Project: PRA-ROCR 10(5)
The purpose of this Amendment is to:

Amendment No. 0002
Project PRA-ROCR 10(5)
Rock Creek Park
Solicitation: DTFH71-16-R-00001

Project Name: Beach Drive from Rock Creek Parkway to Maryland State Line

AMENDMENT NO. 1 ①	PMIS NO.	NPS NO.	STATE	PROJECT	SHEET NO.
AMENDMENT NO. 2 ②	044965	821 / 100425	DC	PRA-ROCR 10(5)	D33

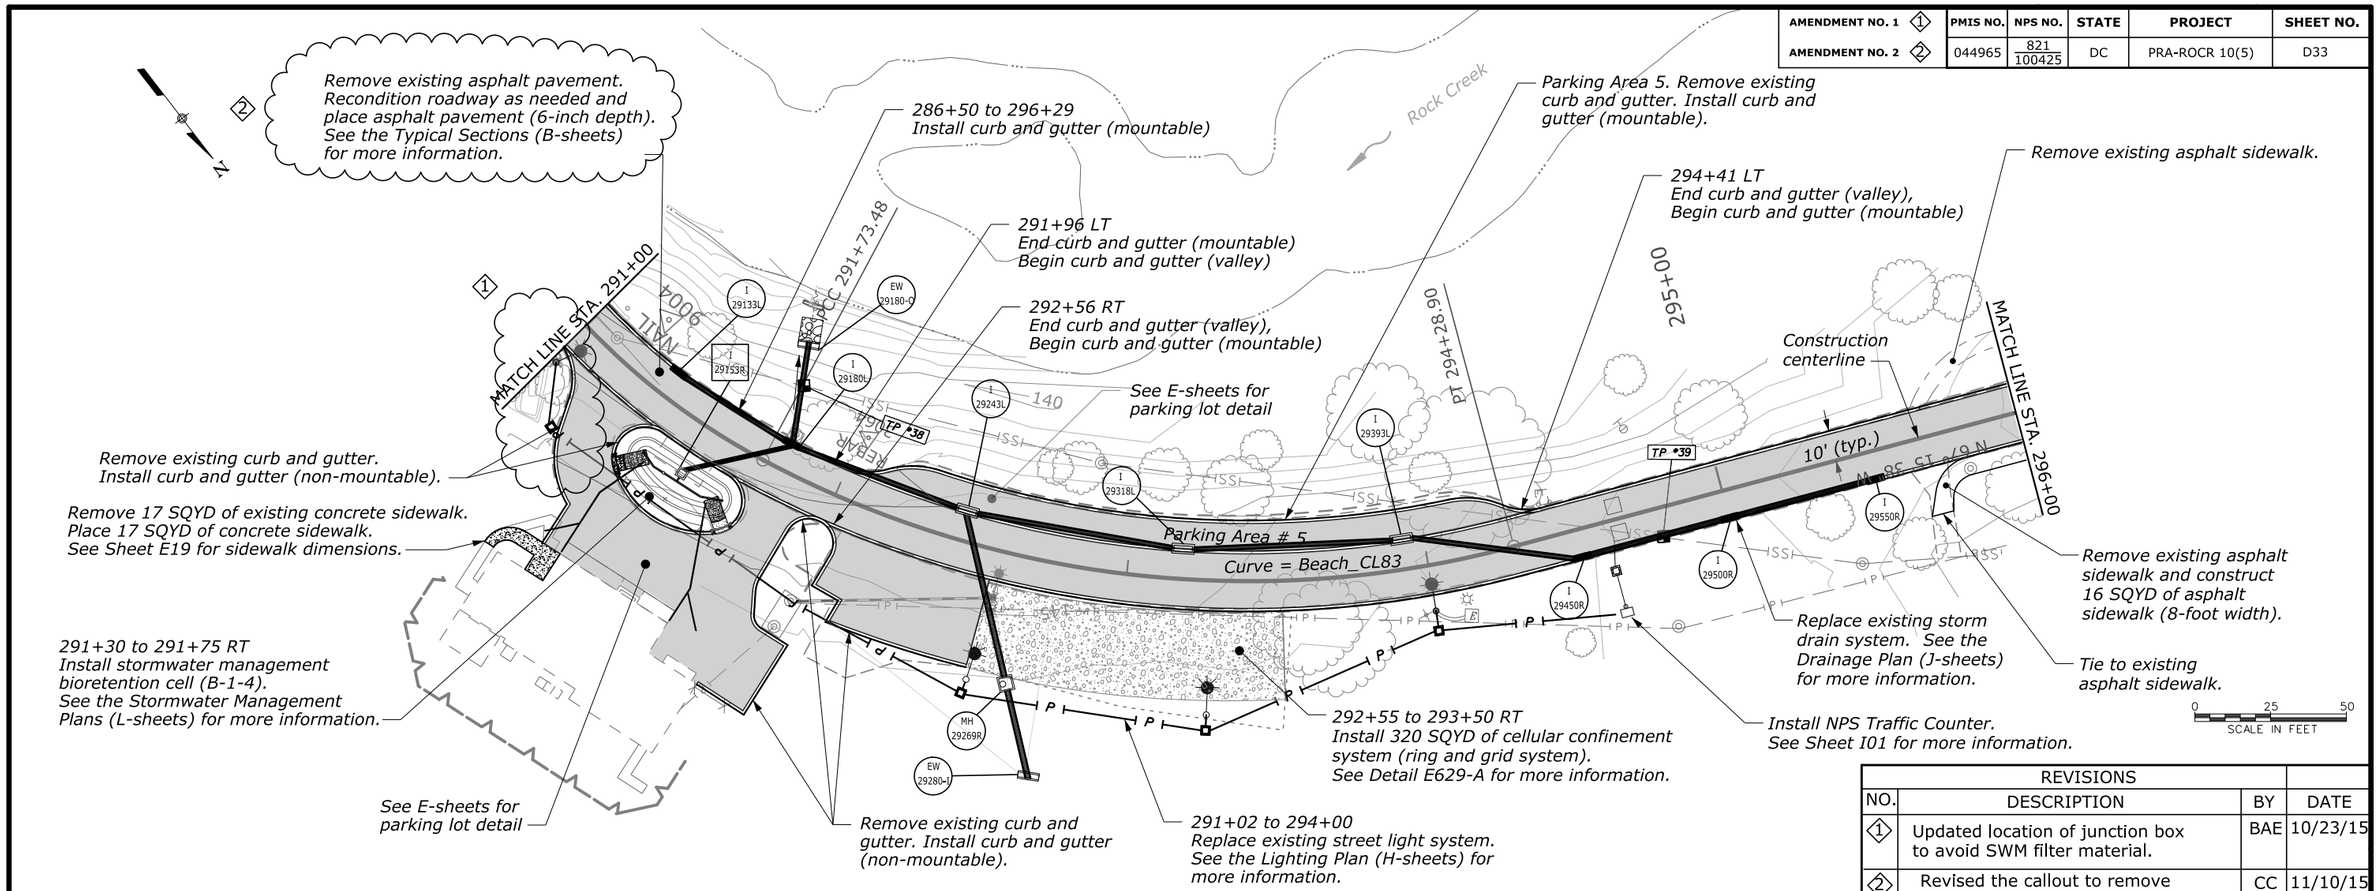
a) Sheet D33 updated to revise the remove existing pavement callout to remove the milling requirement.

REVISIONS			
NO.	DESCRIPTION	BY	DATE
①	Updated location of junction box to avoid SWM filter material.	BAE	10/23/15
②	Revised the callout to remove the milling requirement.	CC	11/10/15

AMENDMENT NO. 2 ①	PMIS NO.	NPS NO.	STATE	PROJECT	SHEET NO.
	044965	821 / 100425	DC	PRA-ROCR 10(5)	D34

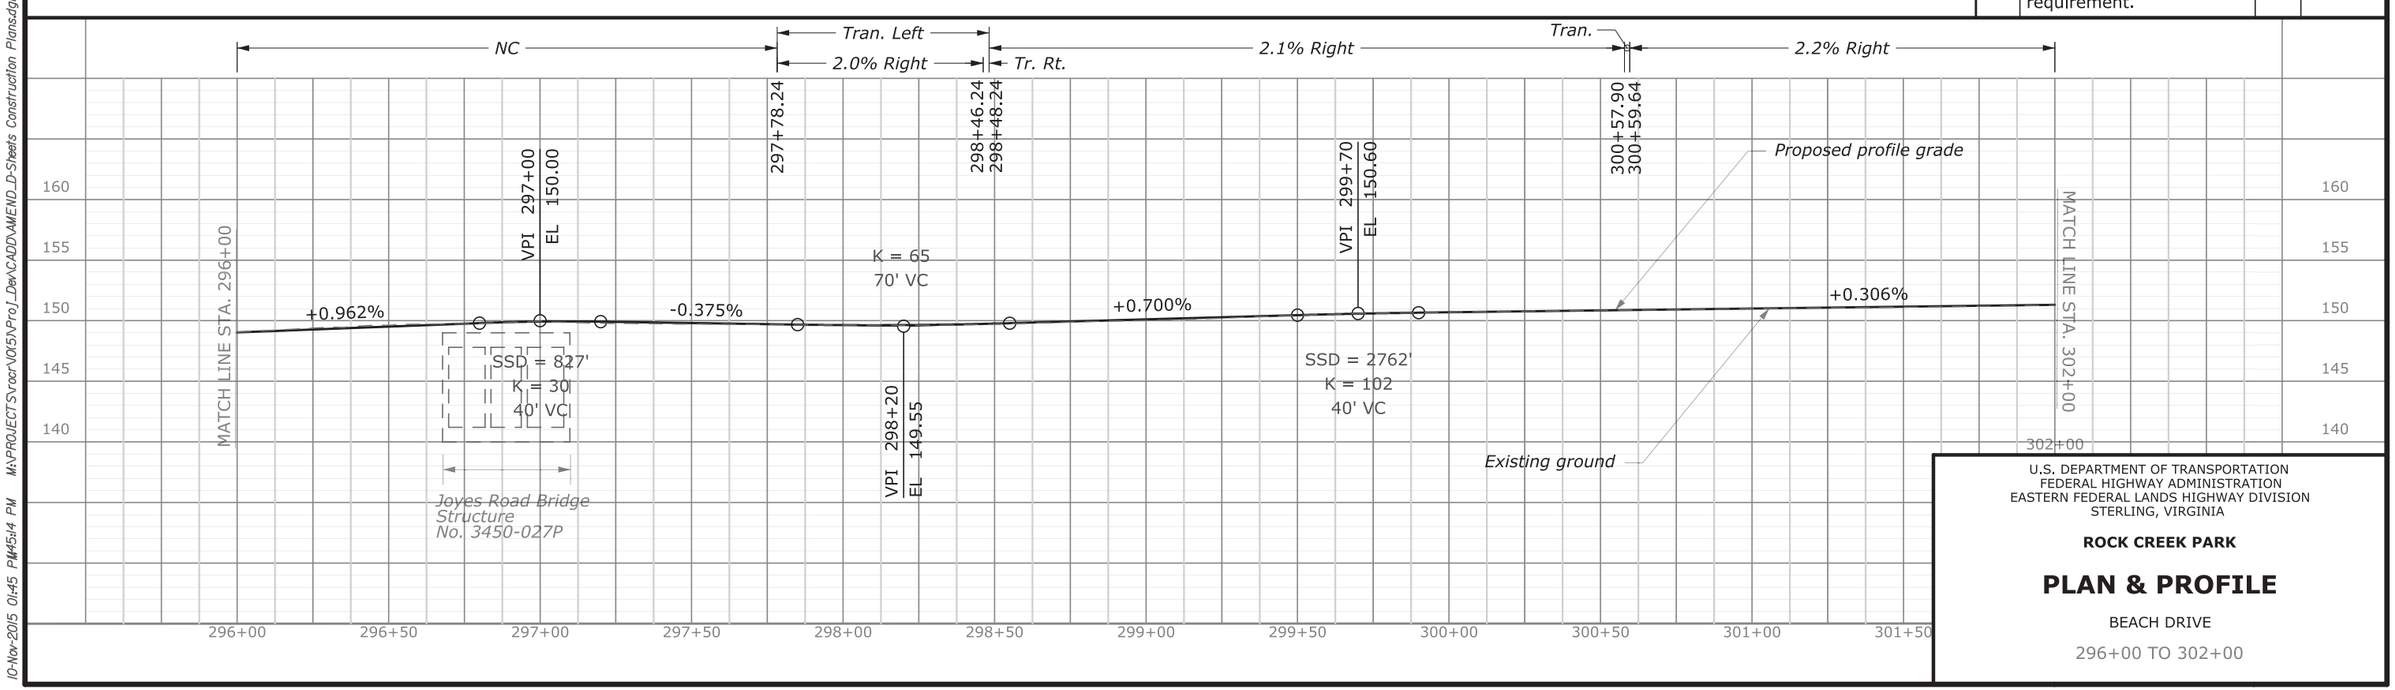
REVISIONS			
NO.	DESCRIPTION	BY	DATE
①	Revised the callout to remove the milling requirement.	CC	11/10/15

AMENDMENT NO. 2 ◇1	PMIS NO.	NPS NO.	STATE	PROJECT	SHEET NO.
	044965	821 / 100425	DC	PRA-ROCR 10(5)	D35

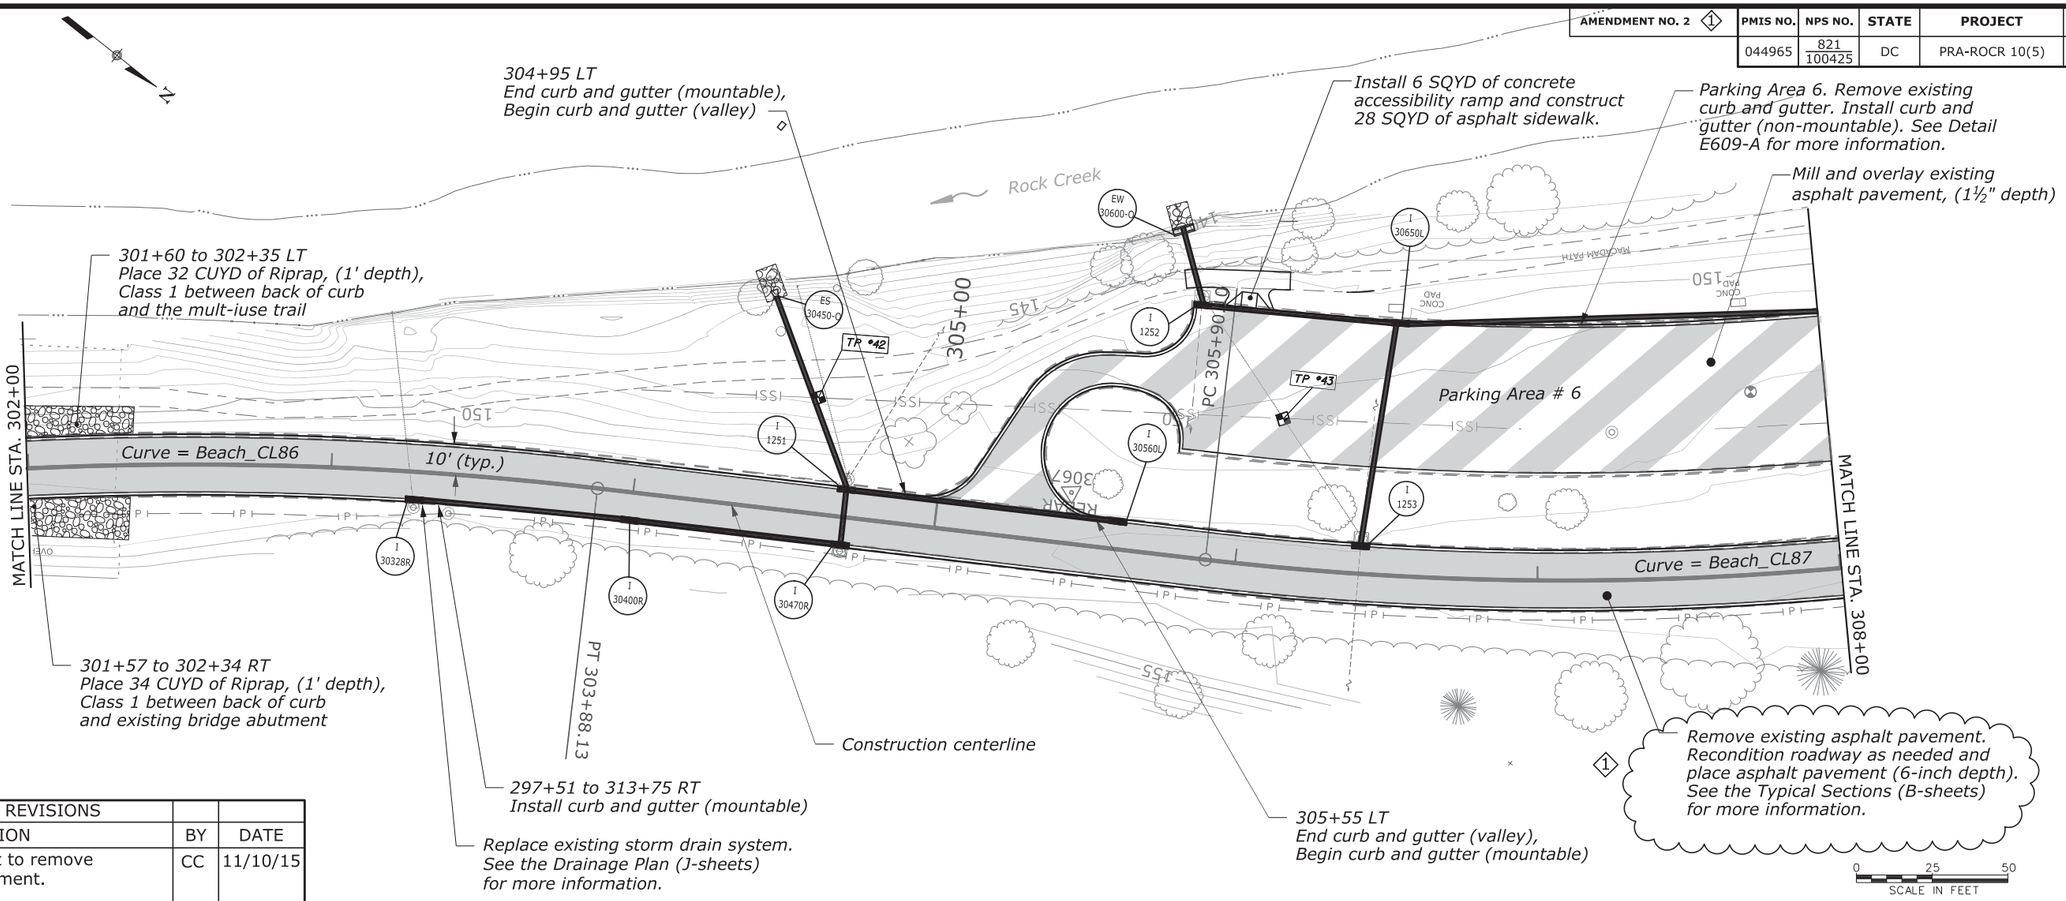
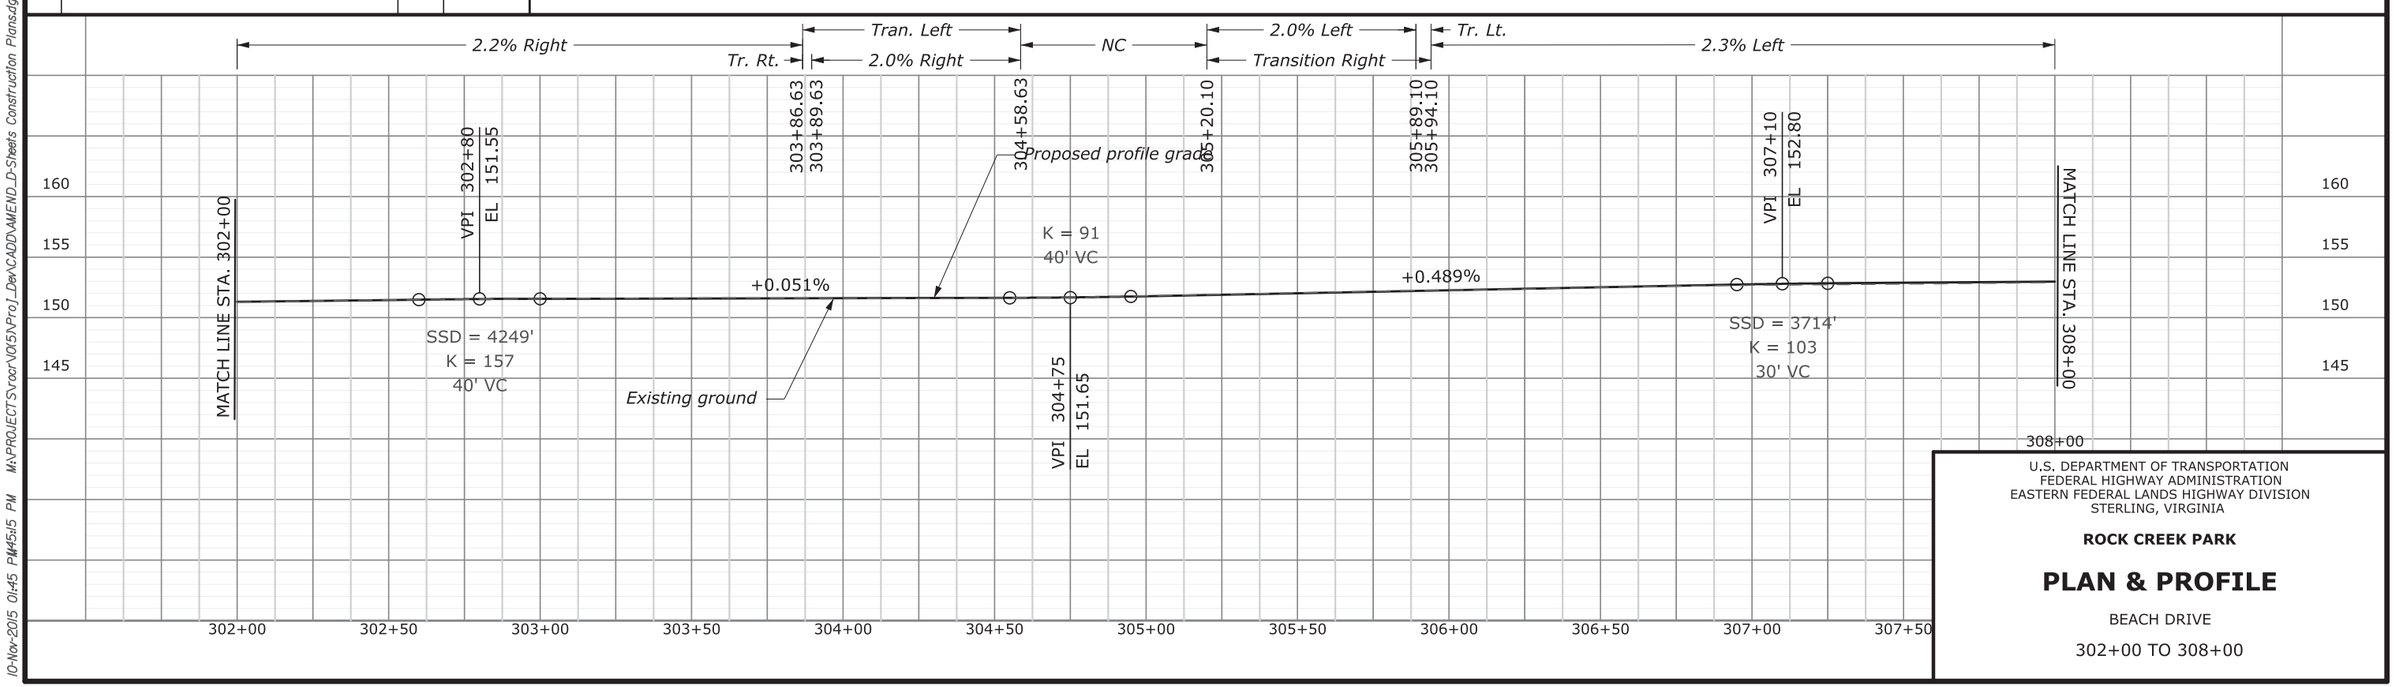
REVISIONS			
NO.	DESCRIPTION	BY	DATE
◇1	Revised the callout to remove the milling requirement.	CC	11/10/15

AMENDMENT NO. 2 ◇1	PMIS NO.	NPS NO.	STATE	PROJECT	SHEET NO.
	044965	821 / 100425	DC	PRA-ROCR 10(5)	D36

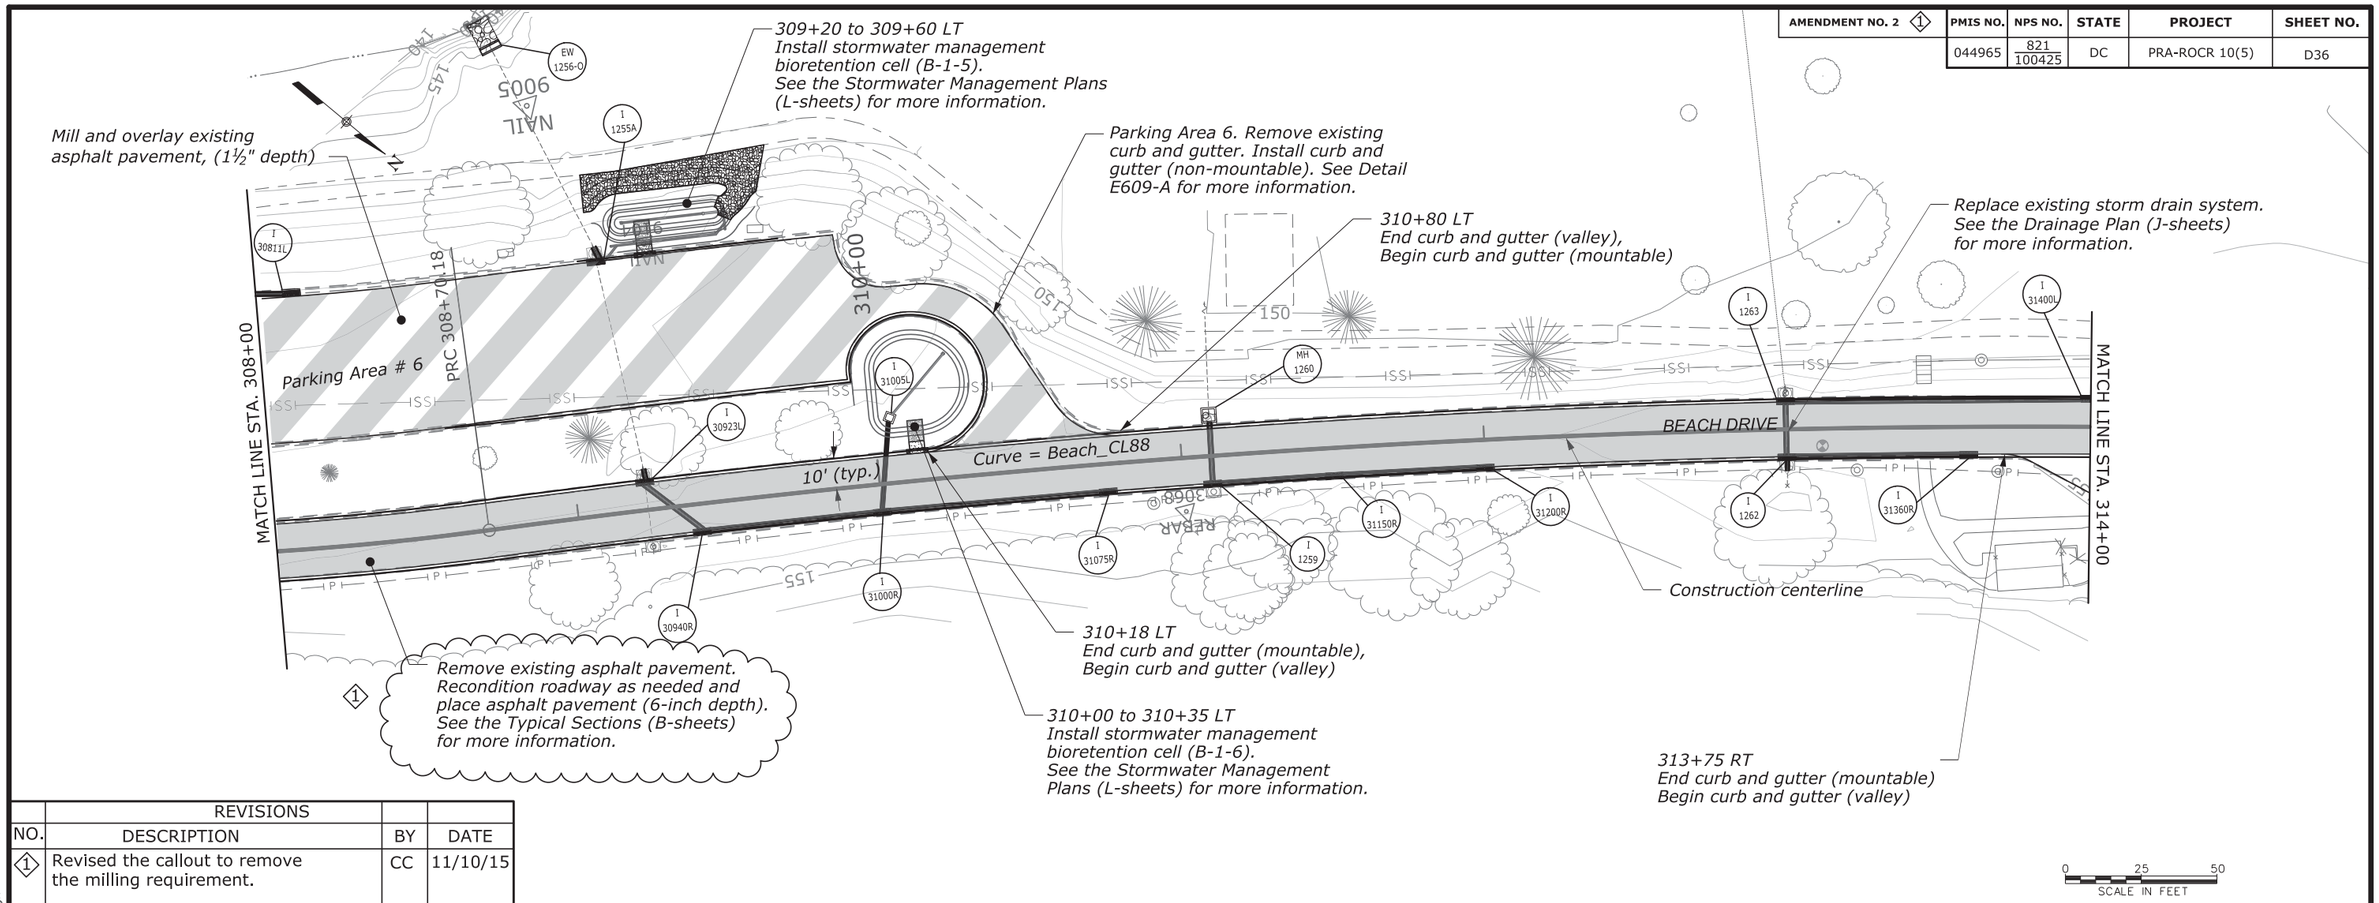
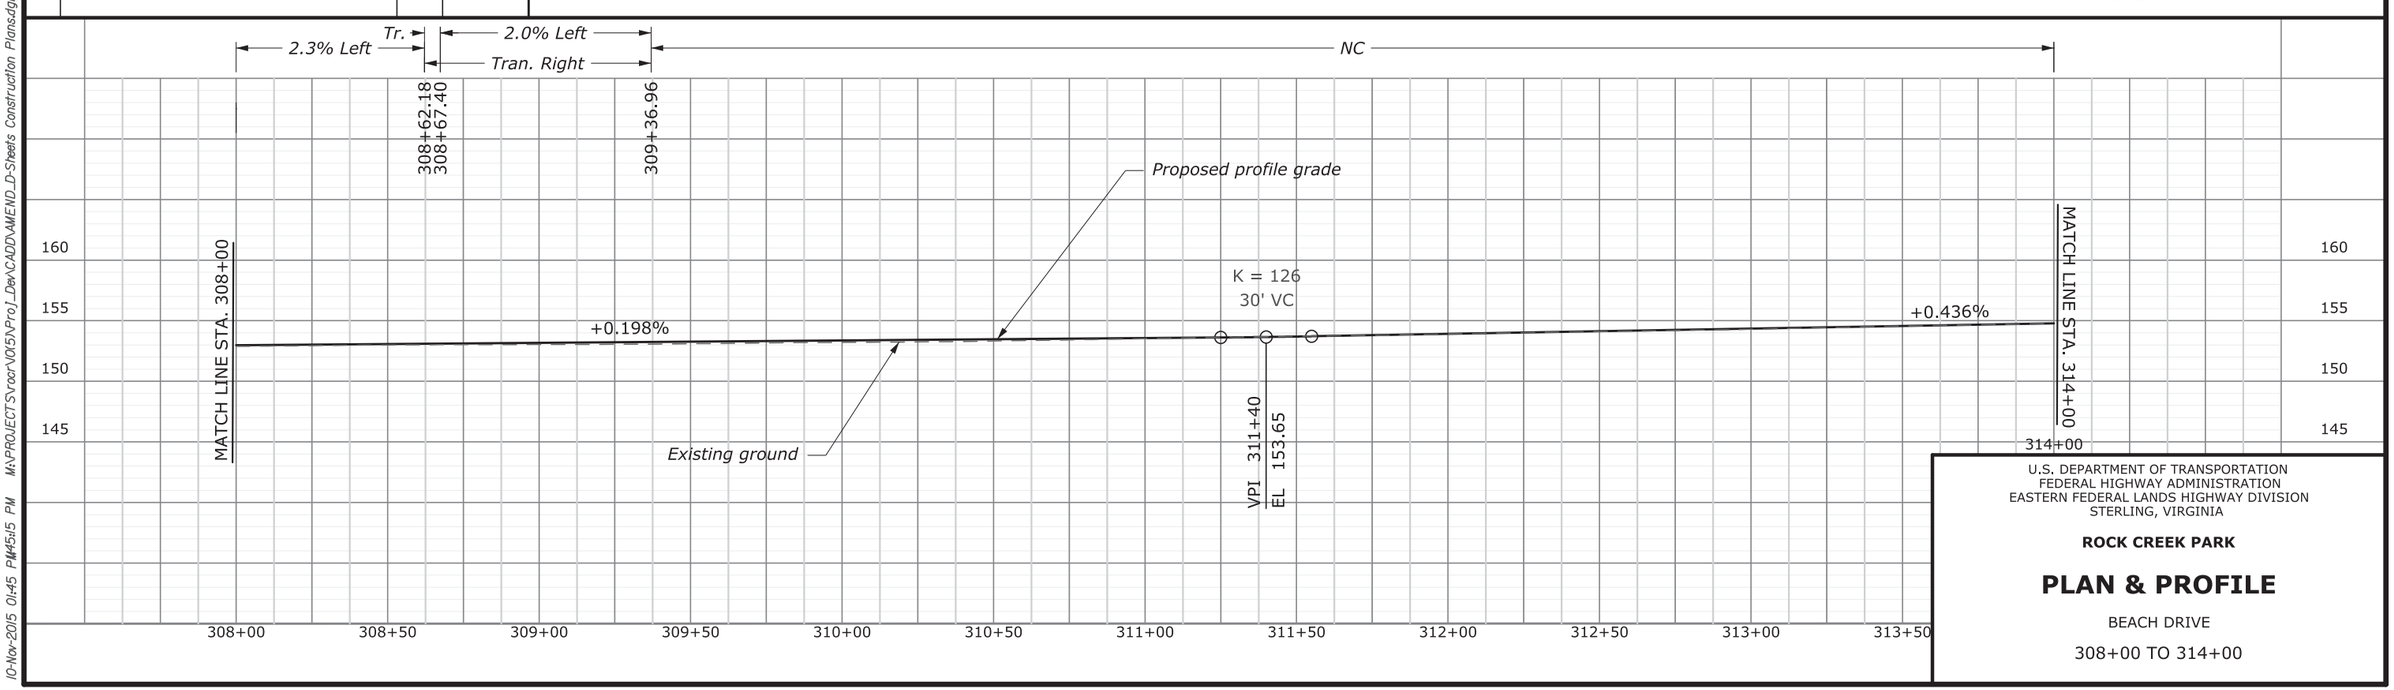
REVISIONS			
NO.	DESCRIPTION	BY	DATE
◇1	Revised the callout to remove the milling requirement.	CC	11/10/15
